Office Action Summary	Application No. 10/767,225	Applicant(s) KUO, YI-LUNG	
	Examiner Noah C. Hawk	Art Unit 3636

DETAILED ACTION

Lee et al., Figure 2

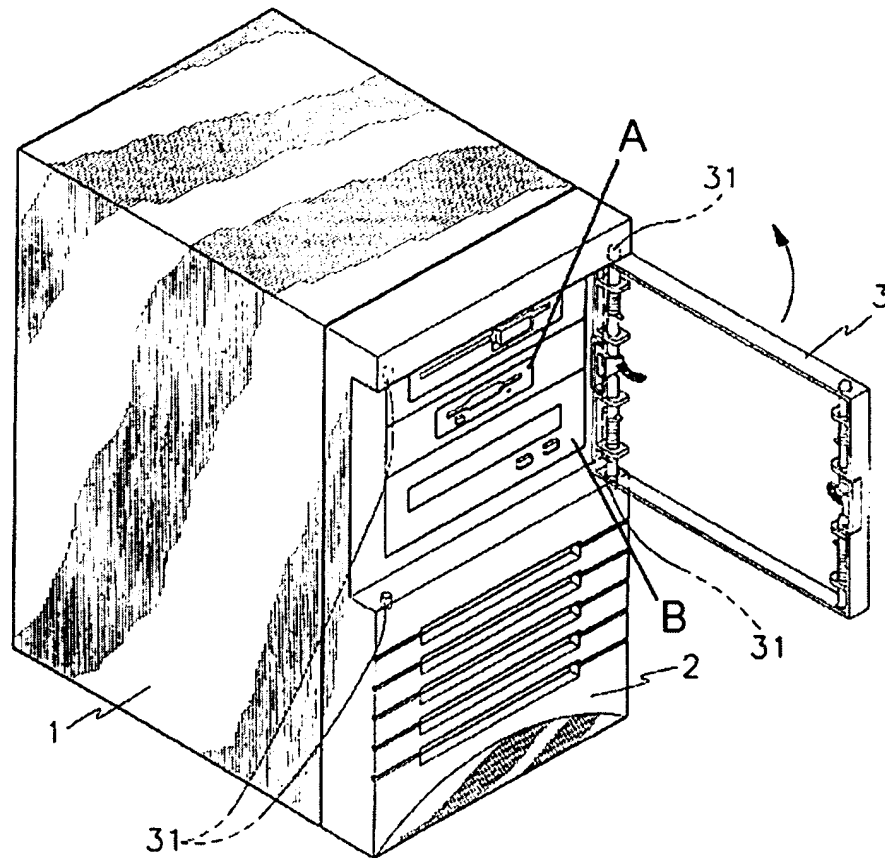
12. Claims 5 and 6 are rejected under 35 U.S.C. 103(a) as being unpatentable over Della Fiora, as modified, as applied to claim 1 above, in view of Lee et al. in US Patent 5926916. Della Fiora, as modified, fails to teach that the plurality of interfaces comprises a 3-½ inch and a 5-¼ inch drive or that the drive door conceals the 5-¼ inch drive. Lee et al. discloses a face plate apparatus concealing an interface for a 3 ½-inch drive (A) and an interface for a 5 ¼-inch drive (B) and a drive door (3) that, while in a closed position, is configured to conceal an interface for a 5 ¼-inch drive (B). It would have been obvious to one of ordinary skill in the art at the time of invention to modify the device of Della Fiora, as modified, by using the face plate apparatus to conceal 3 ½ inch and 5 ¼ inch drives and to use a drive door to conceal a 5 ¼ inch drive as taught by Lee et al. in order to protect the drives and allow the user to access the drive more easily.
